**STAFF REPORT: JULY 9, 2025 MEETING**

**APPLICATION NUMBER: HDC2025-00**

**ADDRESS: 1676 CHICAGO BLVD**

**SCOPE: REPLACE ROOF, REPLACE SOFFITS\***

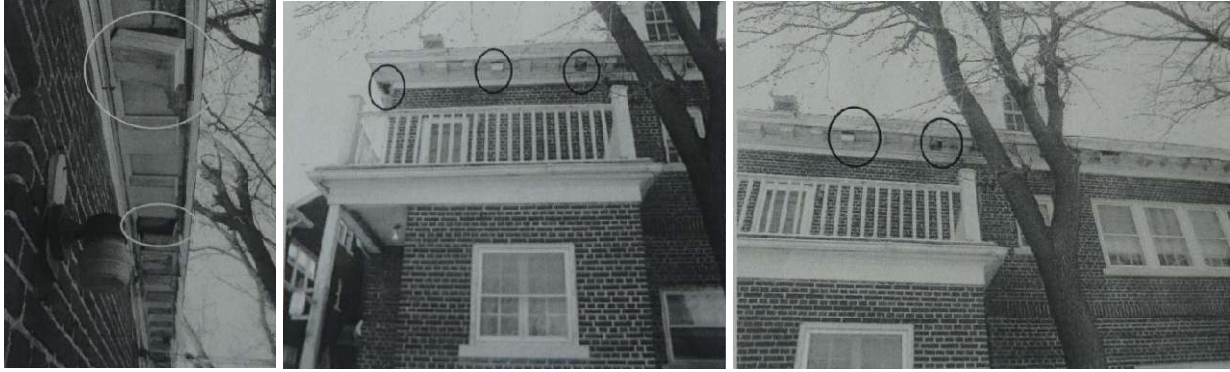
With the current submission, the applicant is seeking an “after-the-fact” COA for work which was recently undertaken at the building’s roof without HDC approval. Specifically, the proposed scope of work is as follows:

- Replace existing asphalt shingle roof including water and ice, synthetic plastic, drip edge
- Install wooden soffit ornament
